February 16, 2012
U7-C-NINA-NRC-120007
10 CFR 2.390

South Texas Project
Units 3 and 4
Docket Number PROJ0772
Responses to Request for Additional Information

Reference: Letter from Tekia Govan to Mark McBurnett, Request for Additional Information RE:
South Texas Nuclear Operating Company Project Topical Report (TR) WCAP-
17202-P, "Supplement 4 to Bison Topical Report RPA 90-90-P-A" (TAC No.
RG0026) dated April 12, 2011 (ML111010099)

Figure 1: BISON comparison to test data for the Generator Load Rejection Test

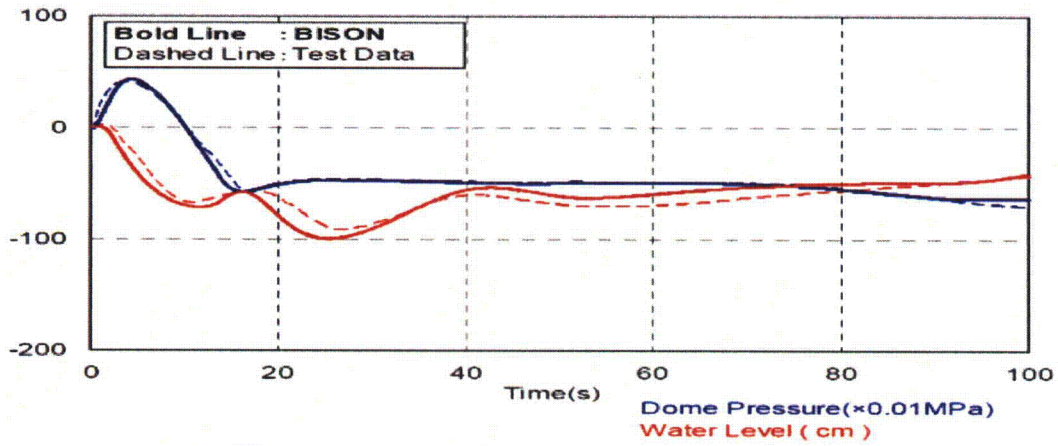
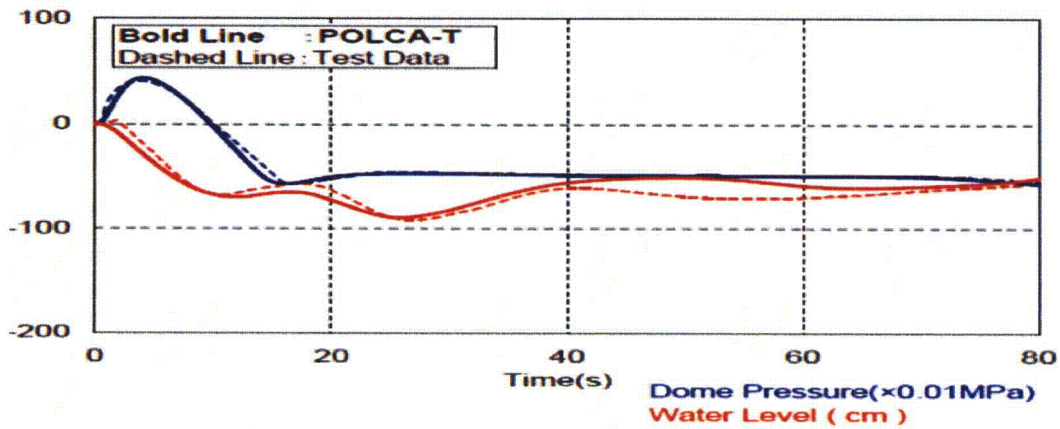
Section 3.5.1 of WCAP-17202 summarizes observations of the current BISON simulation of the Hamaoka-5 start-up tests, but does not reference the supporting documentation.

- a. In order to appreciate the overall improvements in the BISON model predictions after incorporation of the new steam dome water surface condensation model, provide the reference where the BISON calculations of Hamaoka-5 start-up tests are documented or provide the results of comparison of the original BISON code for the Hamaoka-5 start-up tests (pressure in dome, water level, and water subcooling).
- b. Explain whether the third bullet is an experimental observation or a BISON prediction.

Response to RAI 15.00.02-32

- a. BISON calculations of Hamaoka-5 start-up tests are documented in Reference 5 of WCAP-17202.
- b. [
